**RE-EVALUATION**  
of the  
**Environmental Assessment**  
**US 95 Northwest – Washington Avenue to Kyle Canyon**  
**Clark County, Nevada**

**FHWA-NV-EA 07.01**

December – 2012

**Project Name:** US 95 Northwest – Washington Avenue to Kyle Canyon Road

**Figure 1-2 Proposed Interchange**

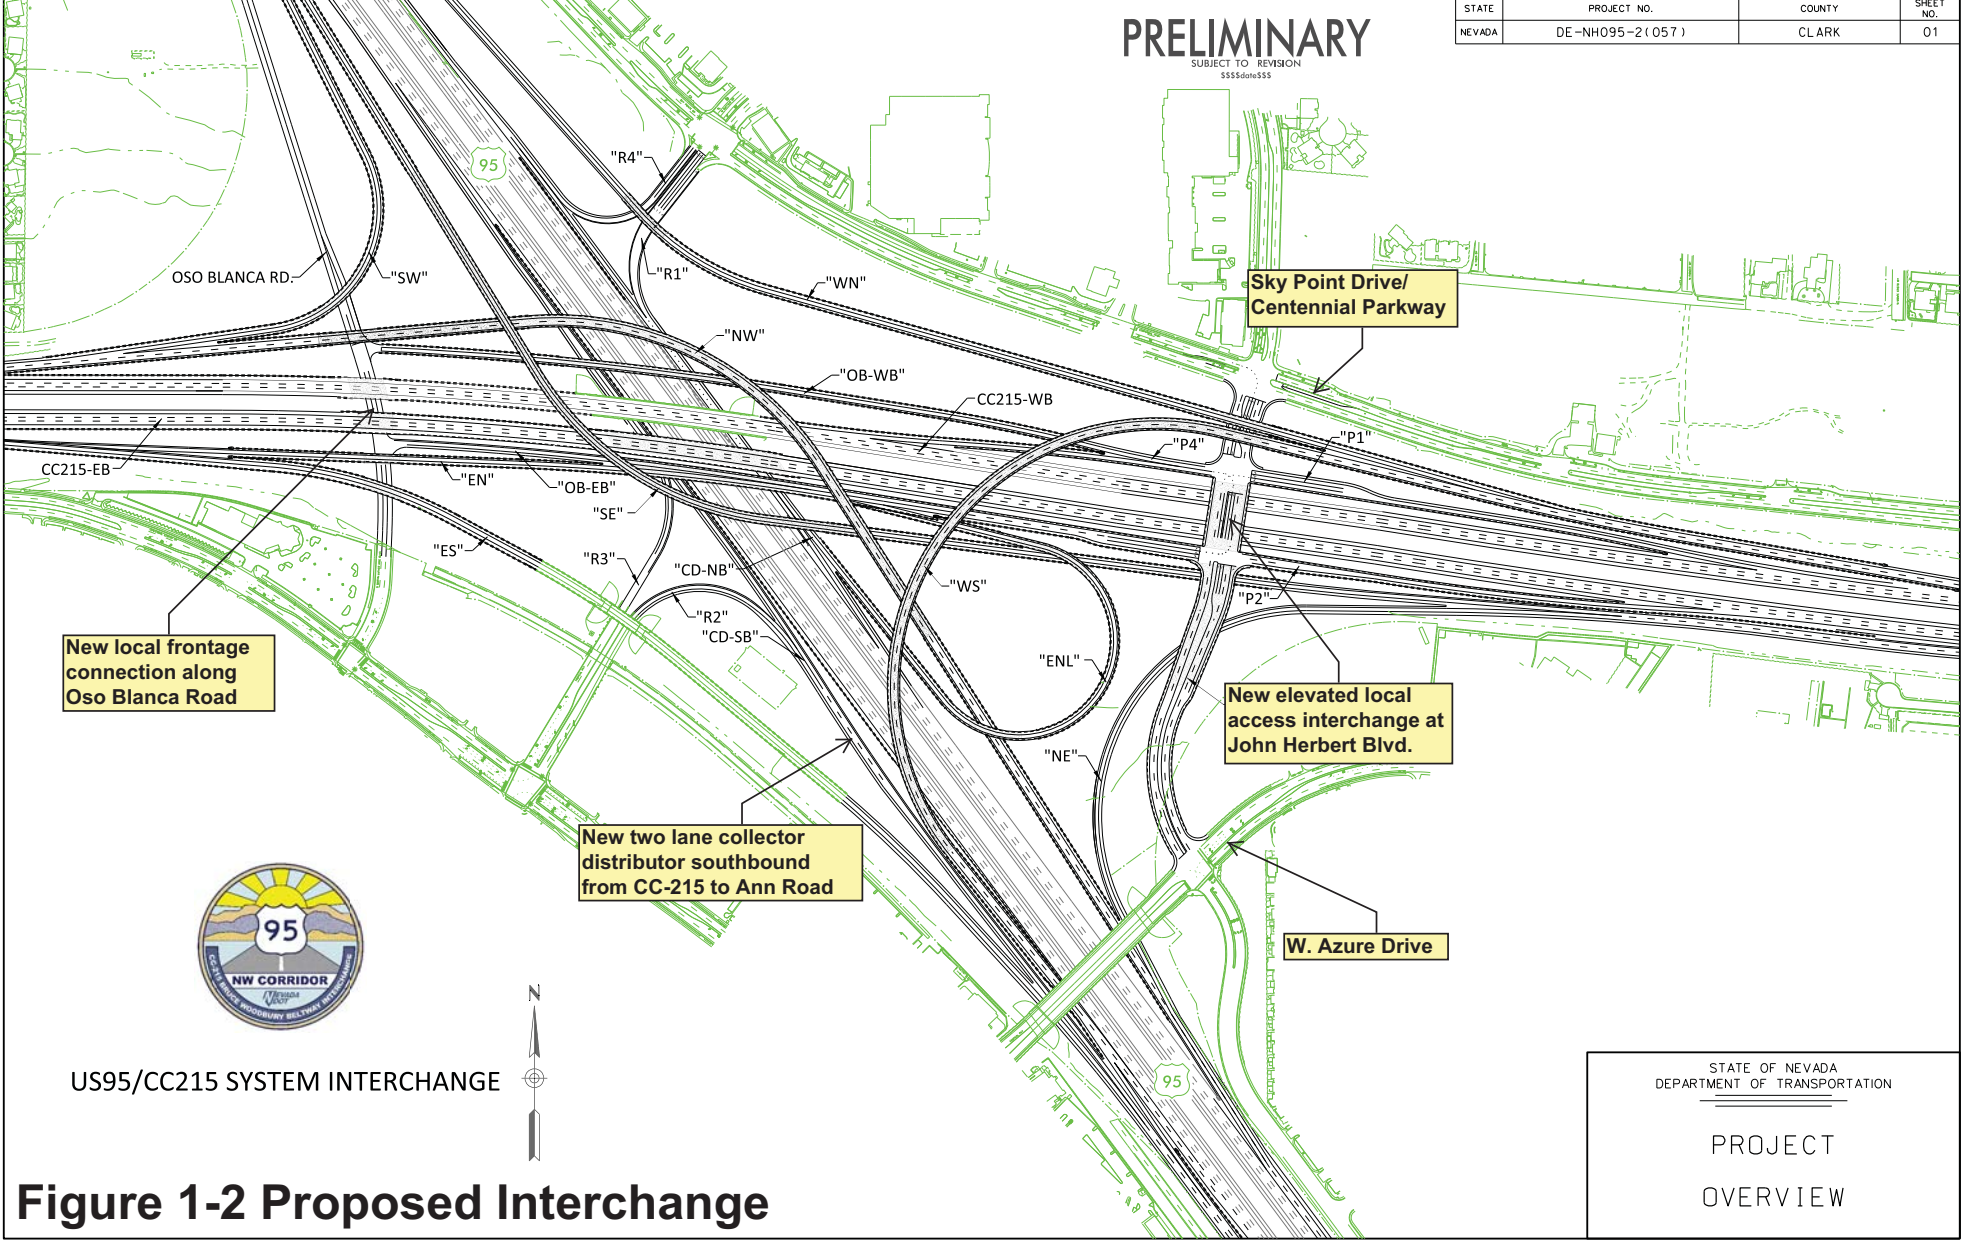
- A new local frontage connection will be provided along Oso Blanca Road (Figure 1-2).
- A two lane collector distributor southbound from CC-215 to Ann Road will be provided to achieve safe movements along the southbound edge of US 95 (Figure 1-2).

- The addition of an elevated local access interchange at John Herbert Boulevard is proposed (Figure 1-2). A small portion of additional right-of-way would be needed in order to complete this connection. The City of Las Vegas is working to secure this parcel in the southeast quadrant of the interchange. The current signal intersection will be upgraded to accommodate the connection.

- Based on current funding availability for this major transportation project, the scope of work to be constructed in Phase 3 has been divided into four packages. The plan is to complete the system to system interchange over the next 2-10 years (Figure 1-2).

**Figure 1-3 Alexander Parcel ROW**

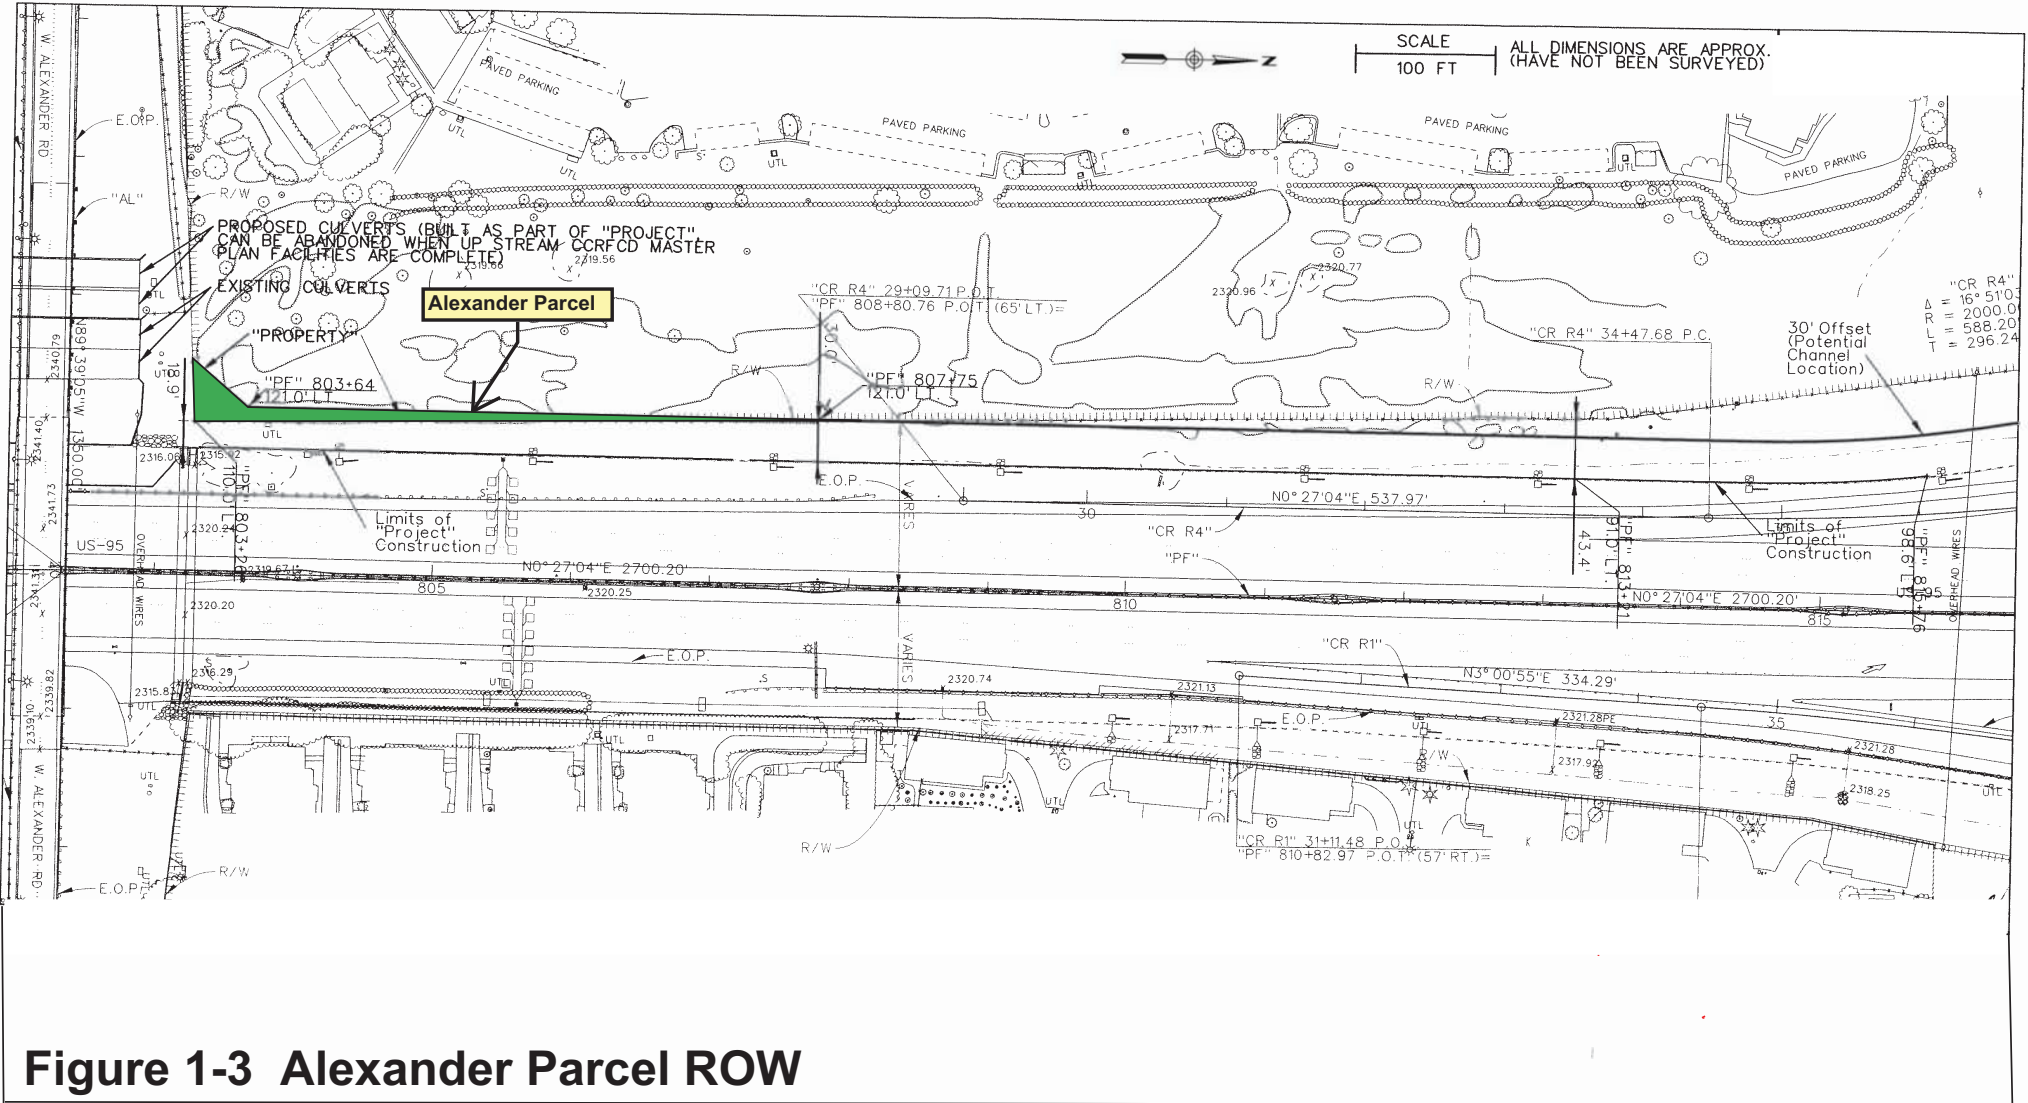
In order to complete construction of improvements at the corner of US 95 and W. Alexander Road a small parcel 138-03-899-025 was acquired by the State of Nevada from Alexander-Tenaya, L.L.C. This parcel which totals 3,108 square feet (0.07 acres) was needed to complete drainage improvements. The parcel is located at the northwest corner of W. Alexander Road and US 95. In addition NDOT executed an Agreement for Construction Outside Right-of Way to complete this work (*Figure 1-3*).

The right-of-way parcel at W. Alexander Road (*Figure 1-3*) was reviewed for wildlife and desert tortoise on January 9, 2012 by NDOT biologist. No Threatened and Endangered Species or critical habitat issues were noted during the site review.

**Figure 1-4 Proposed Local Access ROW**

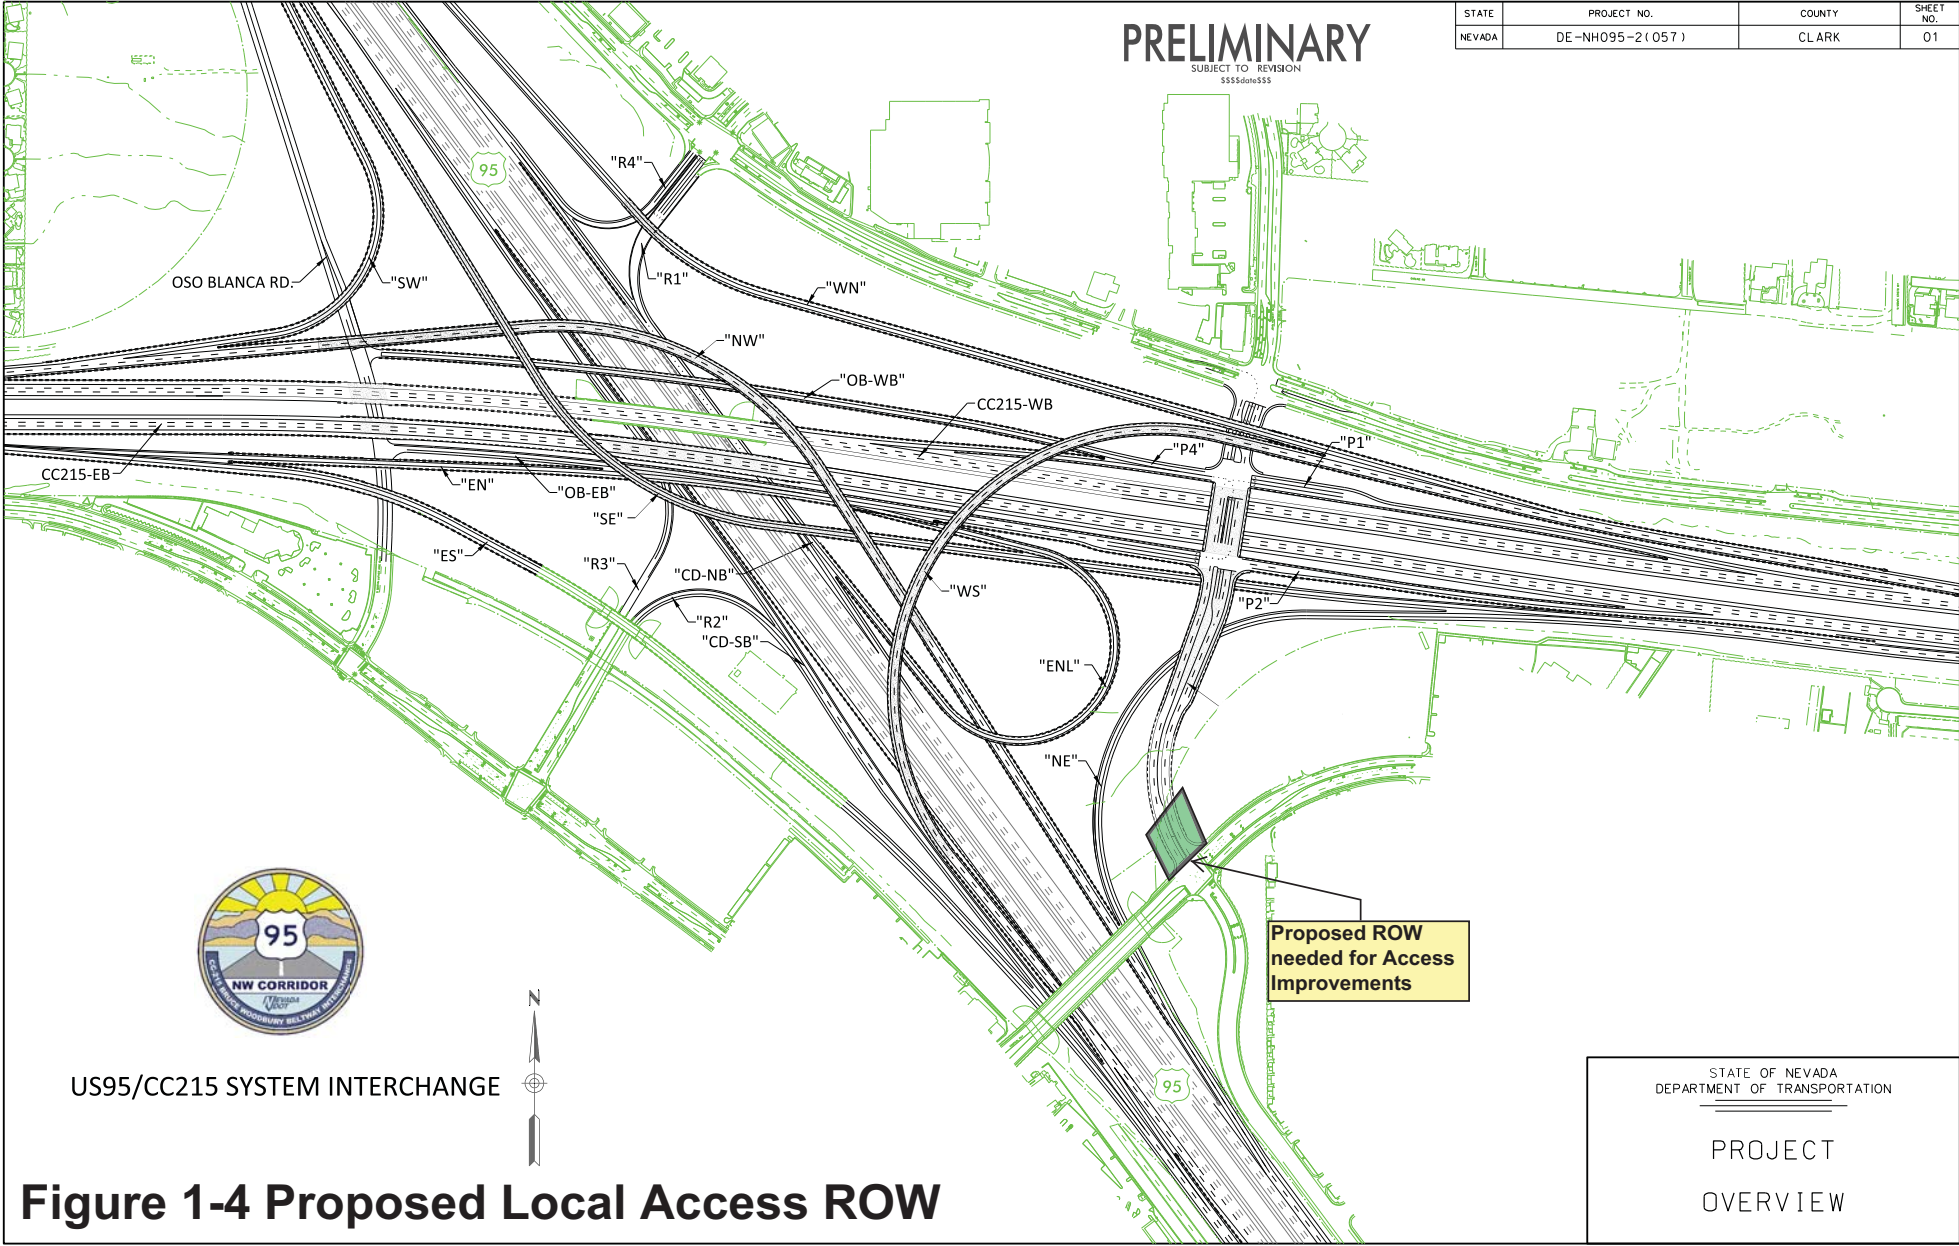
The new design for the US95/CC-215 Beltway system to system interchange proposes local access additions and improvements to the CC-215 Beltway. In order to accommodate this local access, right-of-way will need to be acquired. This acquisition may be by the City or NDOT. The entire parcel 125-28-503-001 which is approximately 2.12 acres is located southeastern quadrant of the interchange (*Figure 1-4*). The impacts to the commercial property will be mitigated according to the Uniform Relocation Assistance and Real Property Acquisition Policies Act of 1970, amended in 1987 (the Uniform Act). This the only new local access road proposed since the approval of the EA.

The Proposed Local Access Right-of-Way (*Figure 1-4*) was reviewed by an NDOT biologist on January 9, 2012 and based on observations from the public right-of-way; additional survey was required on this parcel. NDOT biologist completed a survey on this parcel during the active season for desert tortoise on May 14, 2012. Based on the findings of this survey, a Section 7 consultation is warranted.
